NOTICE OF ACCEPTANCE (NOA)

DESCRIPTION: Series "FD-5555" Outswing PVC French Door w/ & w/o Sidelite and Transom – L.M.I.

APPROVAL DOCUMENT: Drawing No. **MD-555.1 Rev D**, titled "Vinyl French Door and SLT/ TR", sheets 1 through 12 of 12, dated 05/07/13 and last revised on 04/20/20, prepared by manufacturer, signed and sealed by Anthony Lynn Miller, P.E., bearing the Miami-Dade County Product Control Revision stamp with the Notice of Acceptance number and expiration date by the Miami-Dade County Product Control Section.

NOA No. 20-0427.05
Expiration Date: January 23, 2024
Approval Date: September 03, 2020
Page 1

VINYL FRENCH DOOR AND SLT/TR
DESIGN PRESSURE 1
FD-5555

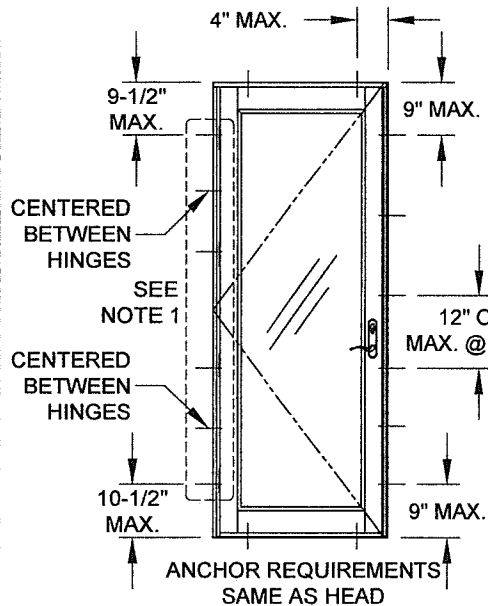
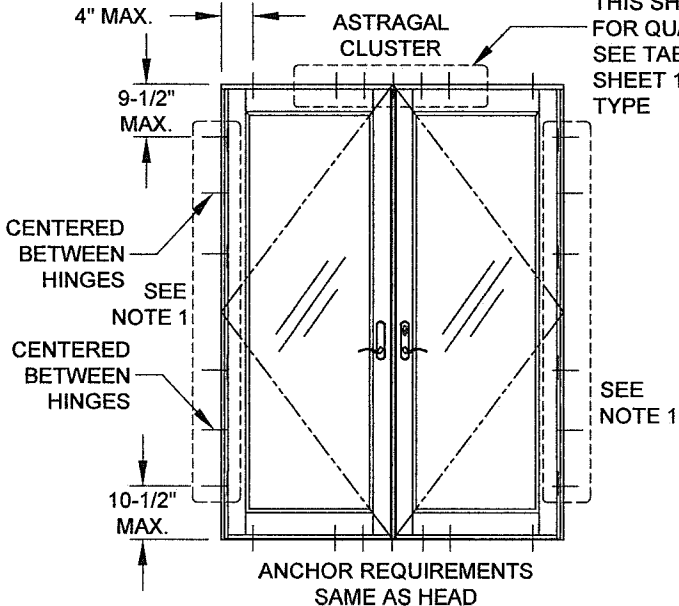
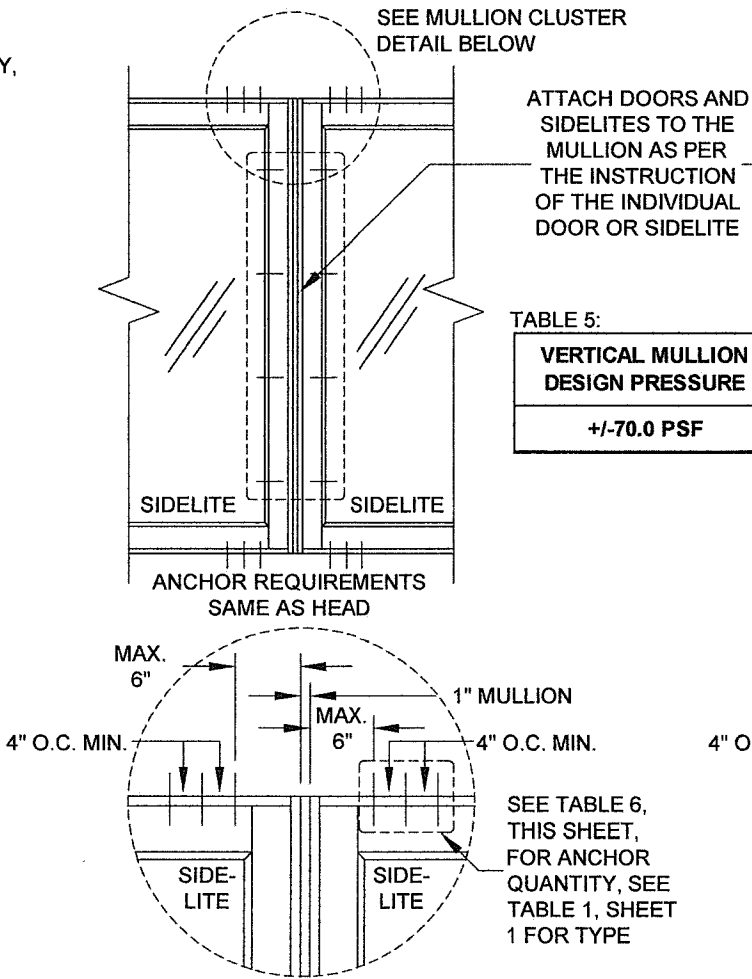
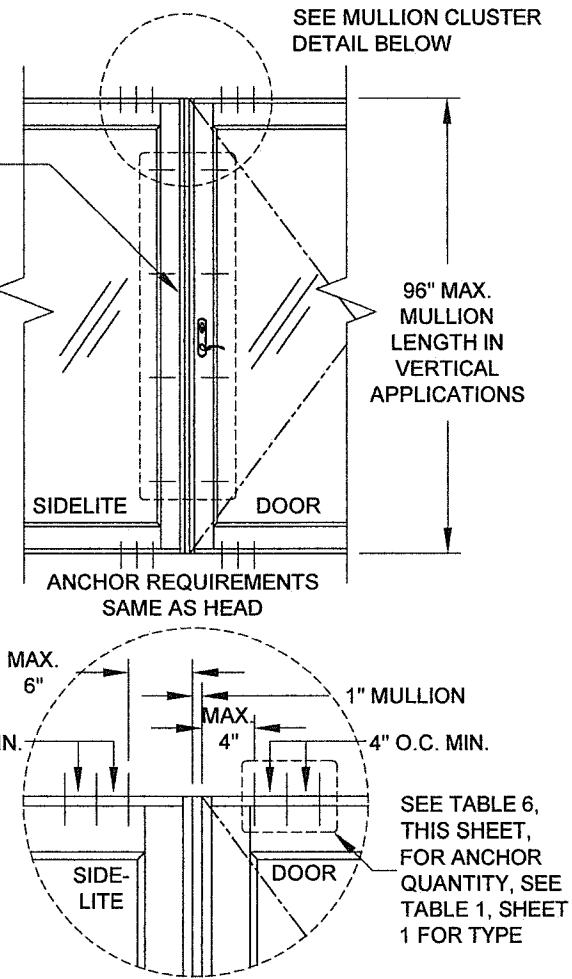
D) ADDED ANCHOR GROUP A TO TABLES 4 & 6.
AK - 4/9/20

1070 TECHNOLOGY DRIVE N. VENICE, FL 34275 (941)-480-1600					
REGISTRATION #29296				VINYL FRENCH DOOR AND SLT/TR		Date		5/7/13	
Series Desc.		Title		CORNER DETAILS AND BOM				J ROSOWSKI	
FD-5555		Scale		NTS		Sheet		11 OF 12	
DWG		No.		By		Drawn		MD-555.1	
Rev.		D		1		Rev.		D

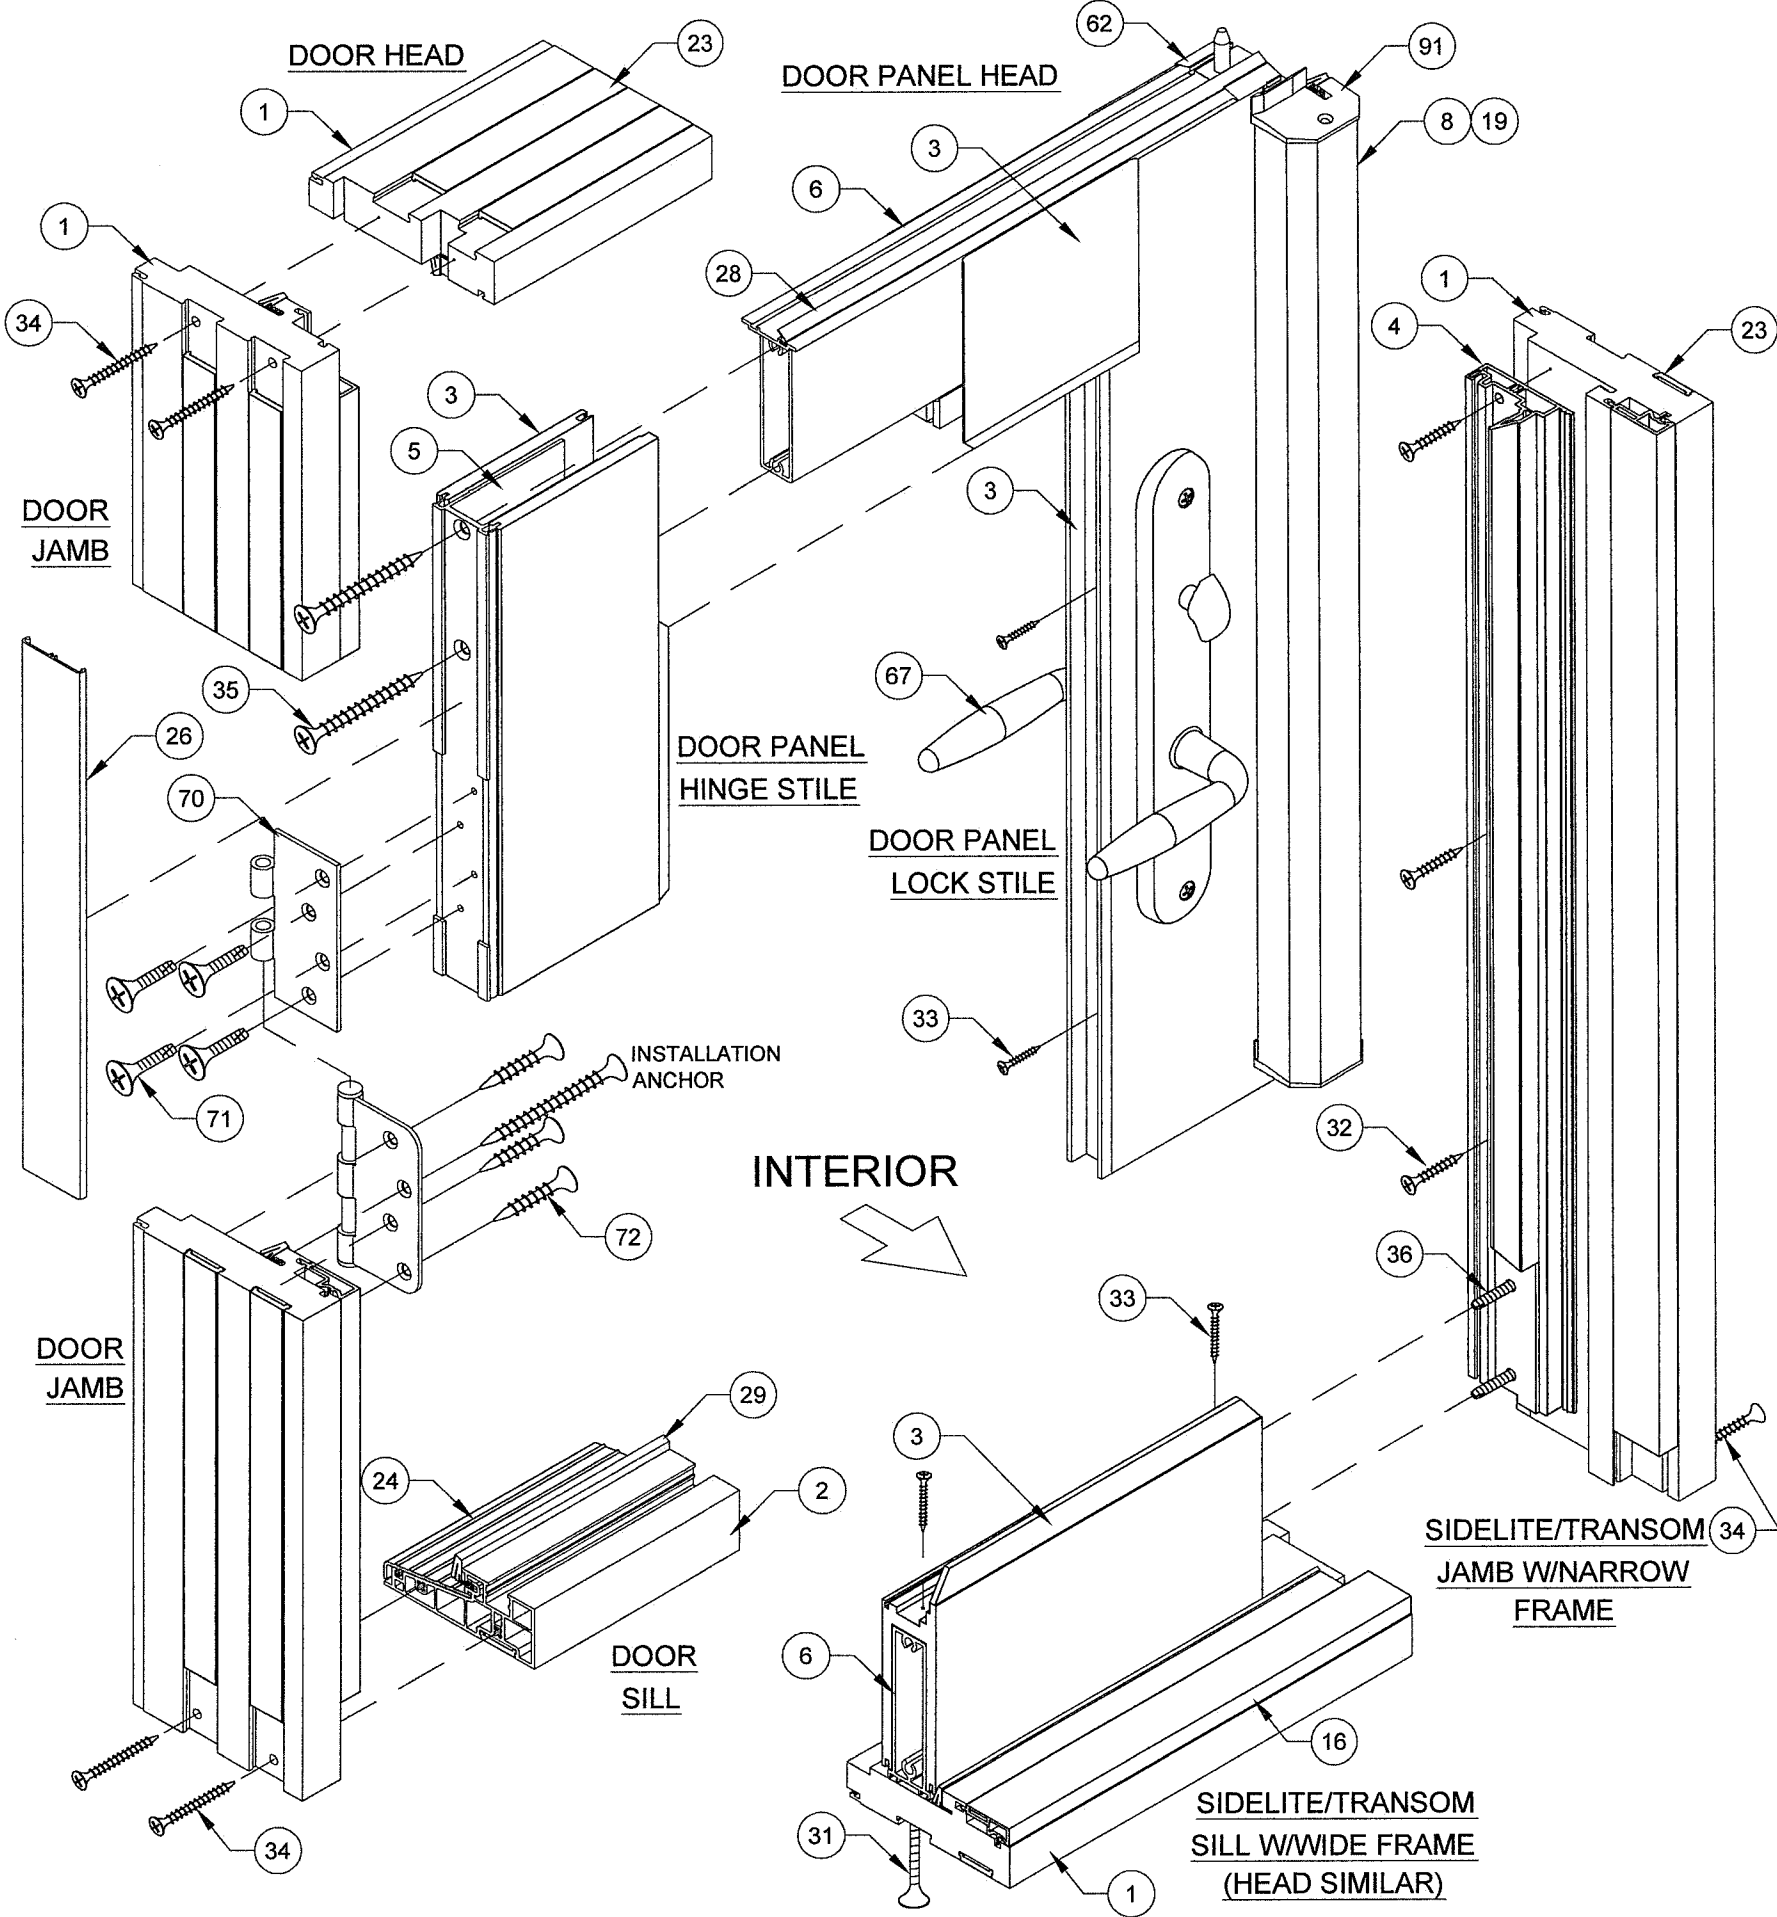
Revision
D) ADDED BACKBEDDING.
AK - 4/9/20
